BAR 18-01-03
1602 Gordon Avenue
Tax Parcel 090013000
Montessori Education Trust, Inc., Owner/ Lindsey Munson, Applicant
New addition

**CITY OF CHARLOTTESVILLE
BOARD OF ARCHITECTURAL REVIEW
STAFF REPORT
May 15, 2018**

BAR 18-01-03

Re: Certificate of Appropriateness - BAR 18-01-03
1602 Gordon Avenue
Montessori School of Charlottesville

EAST ELEVATION

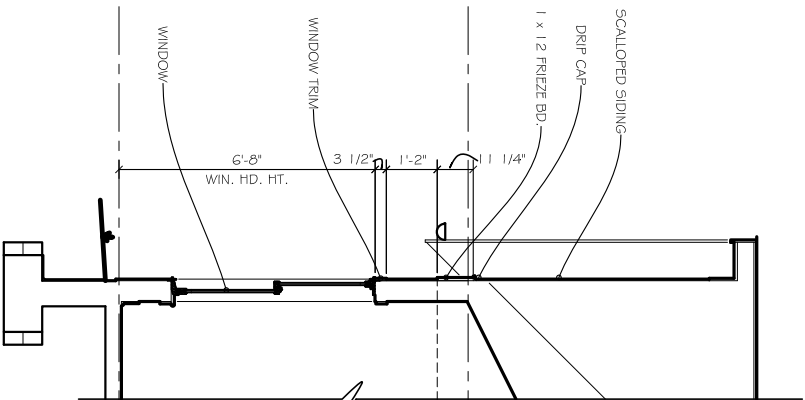
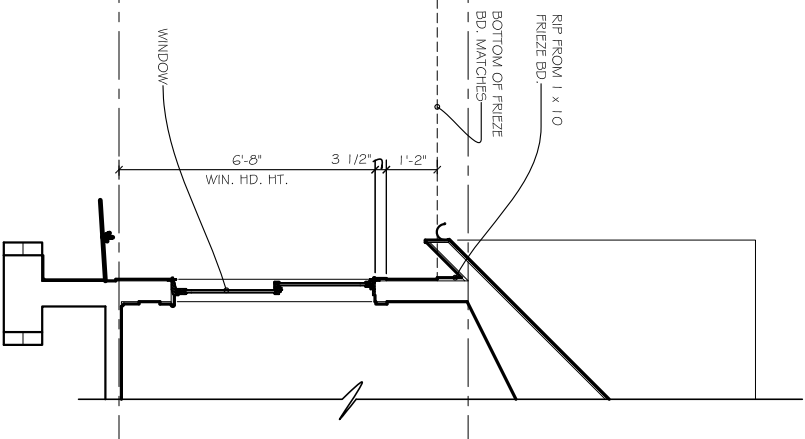
1. Adjusting the frieze board trim band so it picks up the window heads

2. Lengthening the small windows along the Ackley Lane elevation

It is our considered opinion that the distance is too great from the underside of the sloped soffit to the top of the window head to be covered by a single frieze board, additionally it would not fit well with the existing building, and the sloped soffit was used to relate to the existing school building. The frieze boards on the existing school do not touch the window heads. The window head height is set to match the door head height.

In response to this concern we have increased the size of the frieze board, which also acts as a skirt board on gable faces, to a 1 x 12. That leaves 14" from the bottom of this board to the window heads. The bottom side of all frieze boards and gable skirt boards will be set at the same elevation.

We have lengthened the small windows on the Ackley Lane elevation to match the window size used on the rest of the addition. We have positioned these windows centered on the gable, as shown, because of the kitchen's location in the interior of the classroom.

NORTH ELEVATION

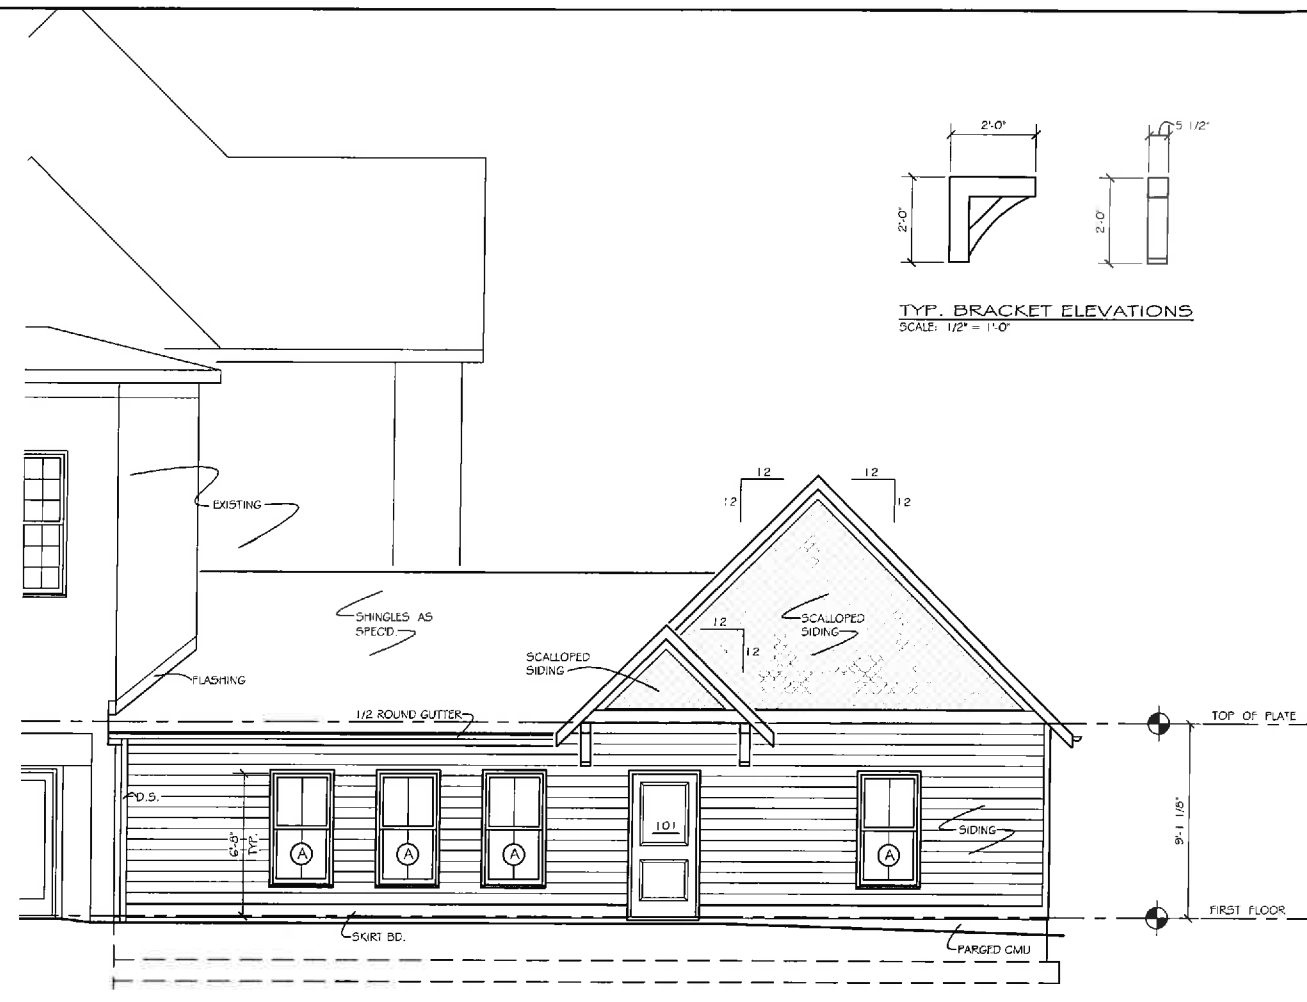
3. Reducing the window in the front of the building under the gable to a single much taller window

We have deleted the two 2' x 2' windows in the front gable and have replaced them with a single 3' wide x 3'-6" tall window. At a window head height of 13', this window fits between the sloped interior ceiling and the 1 x 12 skirt board referenced above, and also the front porch roof.
